# EAGLE TECHNICAL BULLETIN

**Eagle Technical Bulletin Number: TB-E407-789-20**

**Purpose:** To prevent contact between the main driveshaft and the engine firewall closeouts.

Figure 1: Firewall Pan Installation

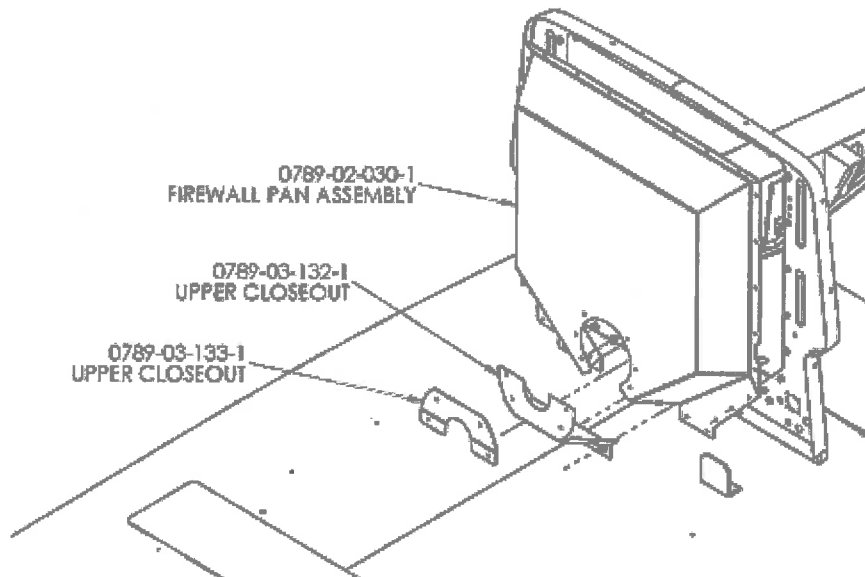
1. Gain access to the 0789-02-030-1 Firewall Pan Assembly IAW Chapter 63 of the Instructions for Continued Airworthiness ICA-E407-789. See Figure 1.
2. Measure the clearance between the engine to transmission driveshaft and the Upper (P/N 0789-03-133-1) and Lower (0789-03-132-1) closeout panels, as shown in Figure 2. Confirm spacing is within the tolerances shown in Figure 2. If the closeout opening is not within the tolerances, adjust the hole size per **PART II** of this TB.

Figure 2: Engine to Transmission Driveshaft Firewall Closeout Clearances

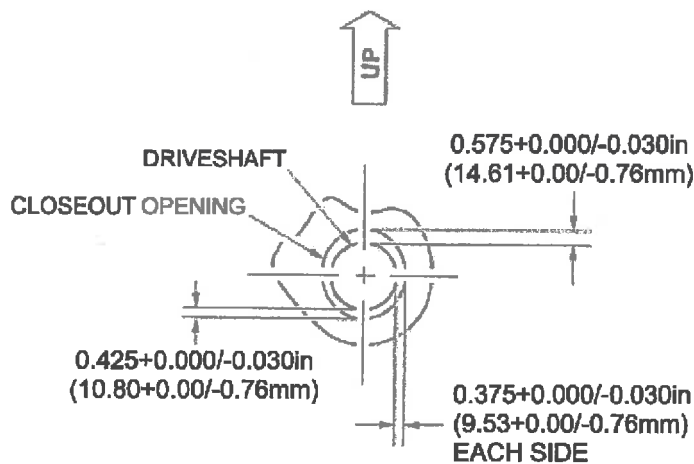
Note: It is recommended that the closeout opening hole size be made as large as possible, given the allowable tolerances, shown in Figure 2.

1. Mark the Upper (P/N 0789-03-133-1) and Lower (0789-03-132-1) closeout panels to the largest allowable hole size, given the allowable tolerances, shown in Figure 2.
2. Remove the Upper and Lower closeout panels from the Firewall Pan Assembly.
3. Trim the Upper and Lower closeout panels to the marks obtained in Step 1. Break all sharp edges.
4. Re-install the Upper and Lower closeout panels IAW ICA-E407-789.
5. Perform the aircraft closeout IAW Bell 407 Aircraft Maintenance Manual, BHT-407-MM and ICA-E407-789.
6. Complete and return Sheet 3 of this TB to Eagle Copters to indicate compliance.
